**Addendum #2 7-30-21**

O' Berry Neuro-Medical Treatment Center ELC-2 Window Replacement  
SCO: # 20-22826-01A

ADD-02 SHEET 1

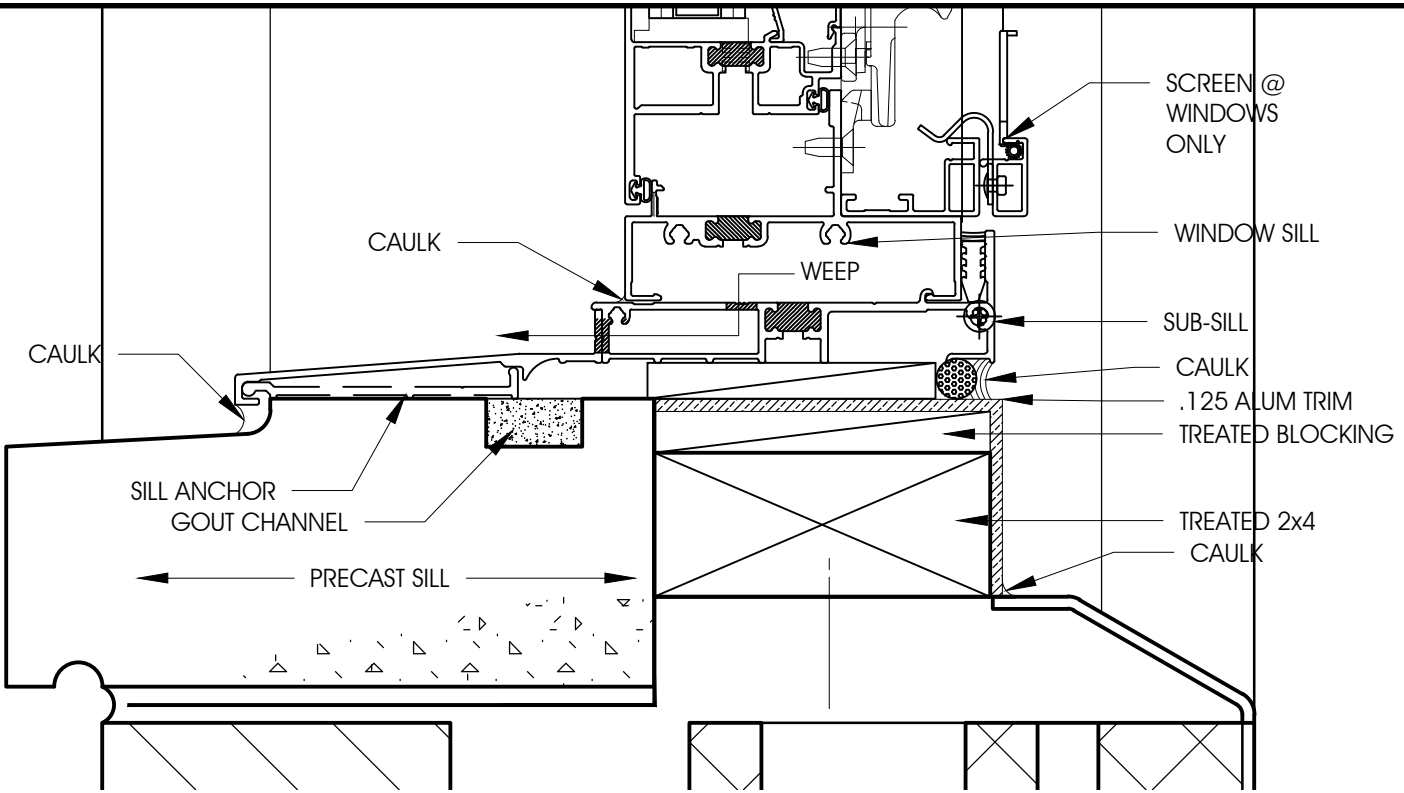
1. A2.0: Substitute Details 07 & 04 with Details 07 & 04 on Sheet 1
  - a. Provide treated blocking and aluminum trim at the sill.
  - b. Grout solid the channel in the concrete sill.

ADD-02 SHEET 2

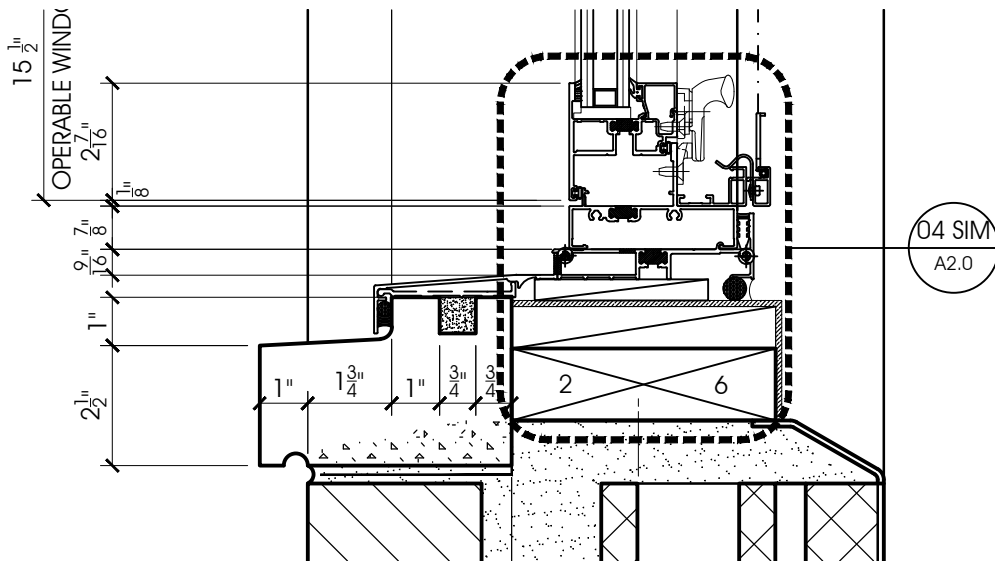
2. A2.1: Substitute Details 01 & 02 with Details 01 & 02 on Sheet 2
  - a. Provide treated blocking and aluminum trim at the sill
  - b. Grout solid the channel in the concrete sill
